North Dakota CarbonSAFE: Project Tundra Oliver County, North Dakota

**APPENDIX J – AIR PERMIT TO CONSTRUCT, AIR QUALITY EMISSIONS
ANALYSIS, AND AIR QUALITY IMPACT ANALYSIS**

Response to Comments Received
by
The North Dakota Department of Environmental Quality
on
Draft Air Pollution Permit to Construct No. ACP-18197 v1.0
DCC East Project LLC - Dakota Carbon Center CO2 Separation and Purification Plant
Oliver County, North Dakota

Figure A-1. Site Layout

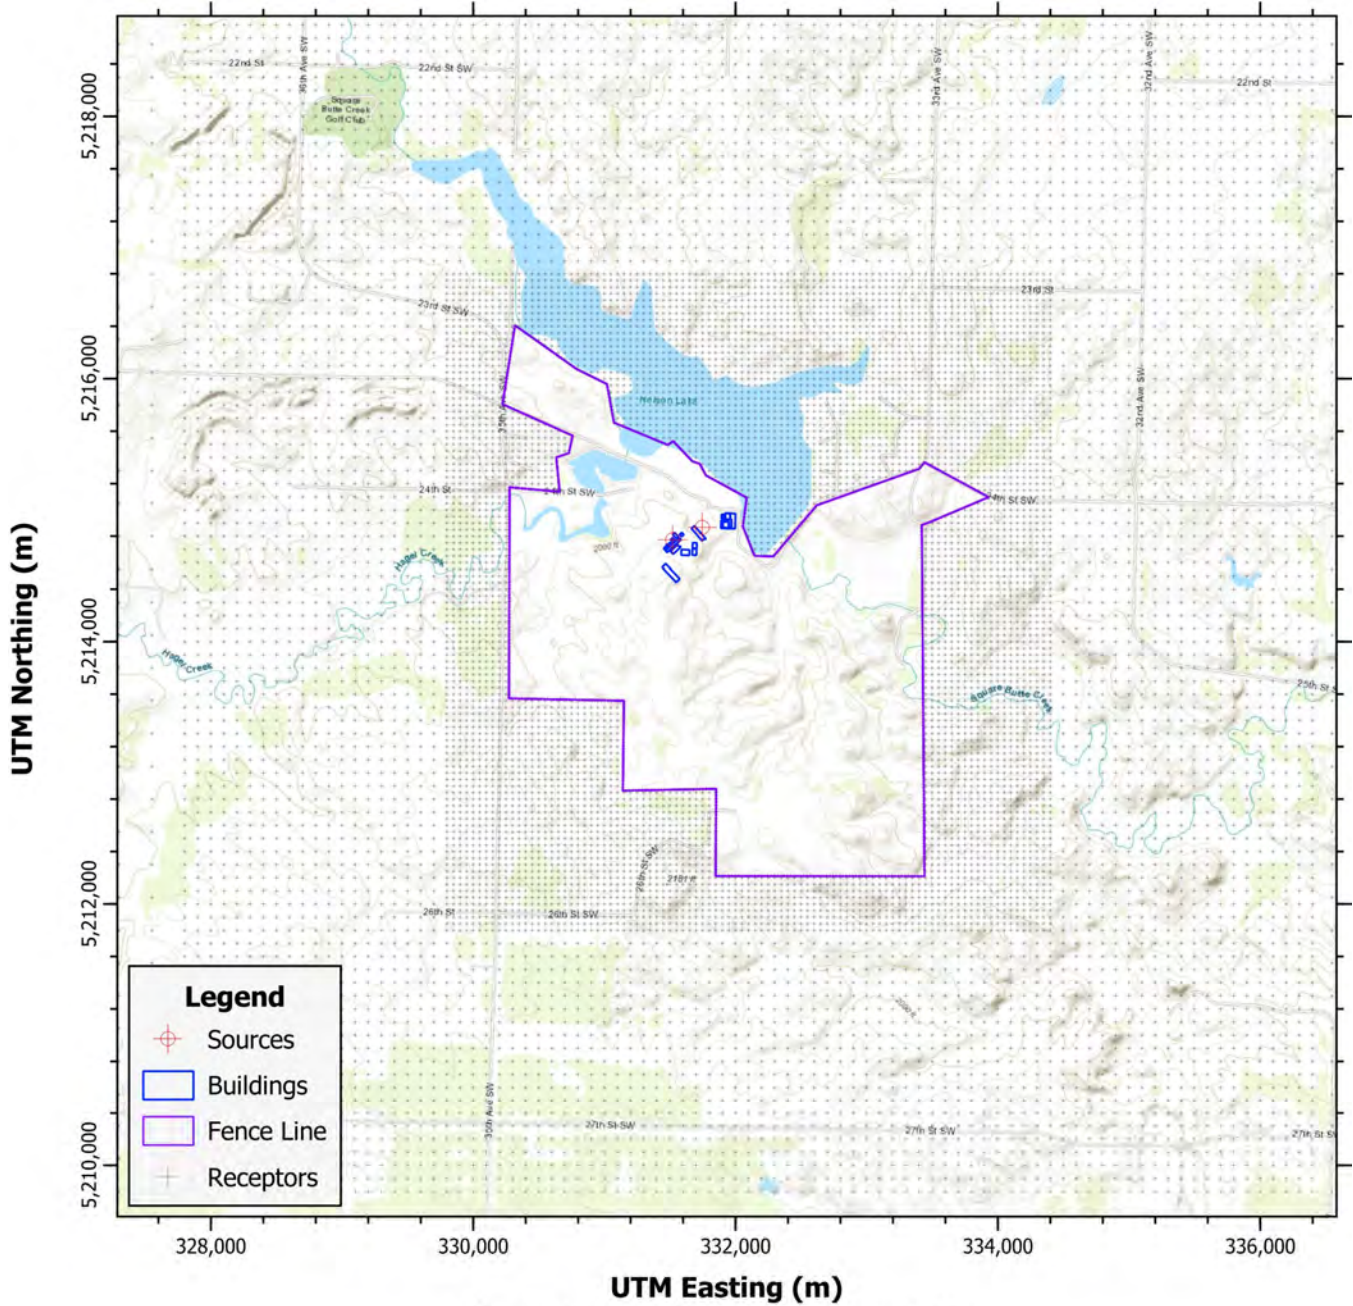
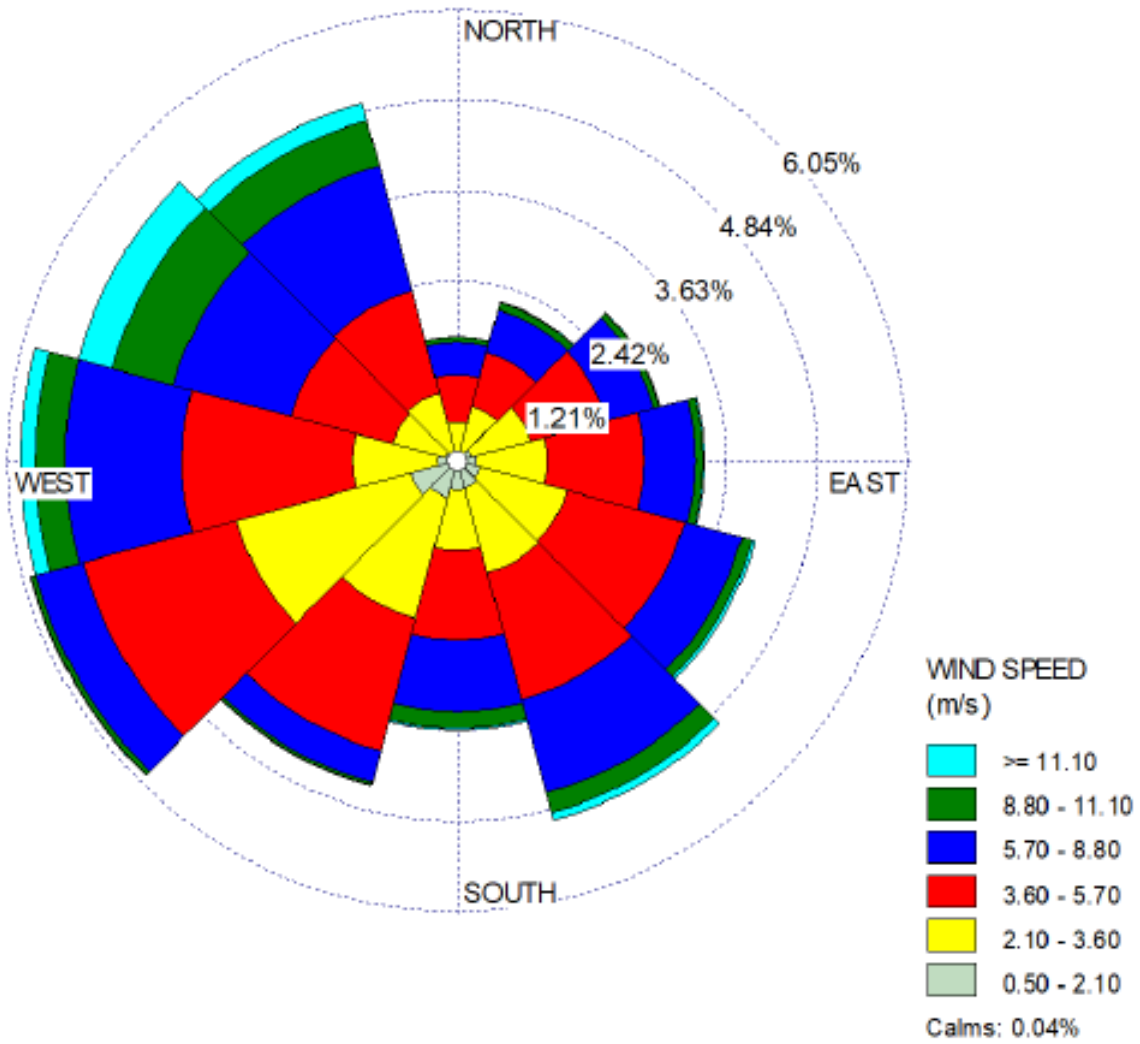
Figure A-1 in Appendix 2 of the AQIA establishes what appears to be an ambient air boundary for the facility that is used to delineate where the air dispersion modeling receptor grid is located. This receptor grid is shown in Figure A-4 and excludes the area inside the defined ambient air boundary.

However, in the permit’s June 2, 2023 application, in Figure 2-1, the larger ambient air boundary contains a smaller defined area labeled as the DCC Separation and Purification Plant and locates the MRY facility’s Unit 1 and Unit 2 in relationship to the DCC facility. The larger ambient air boundary area used in the air dispersion modeling process to establish the modeling receptor grid appears to be the MRY ambient air boundary and the DCC ambient air boundary, according to Figure 2-1 appears to be a smaller area located within the MRY boundary. As it contains MRY Unit 1 and Unit 2, this would appear to be the MRY ambient air boundary.

DCC Response: In its comments, EPA Region 8 recommended that NDDEQ review the cited documents and confirm that the ambient air boundary and associated receptor grid used in the air dispersion modeling for the DCC Facility for accuracy. If that boundary is different than the one used to define the model’s receptor grid, then EPA recommended that the NDDEQ or the applicant rerun the model to confirm that no NAAQS concerns exist.

Minnkota maintains a fenced physical barrier preventing unauthorized entry of the public into the MRY Station. DCC East used the fenced MRY Station property boundary in its modeling demonstrations. The fenced barrier will remain after the start-up of the DCC Facility. The proposed operation plan for the DCC Facility consists of use of the existing MRY Station security gate for designated access across Minnkota property to the DCC Facility secured site. The DCC Facility will be located on leased property, adjacent to the MRY Station, and will be considered “nested” within the footprint of Minnkota’s access restrictions. The MRY Station is a critical infrastructure site and requires strict adherence to security protocols to mitigate access risk. As
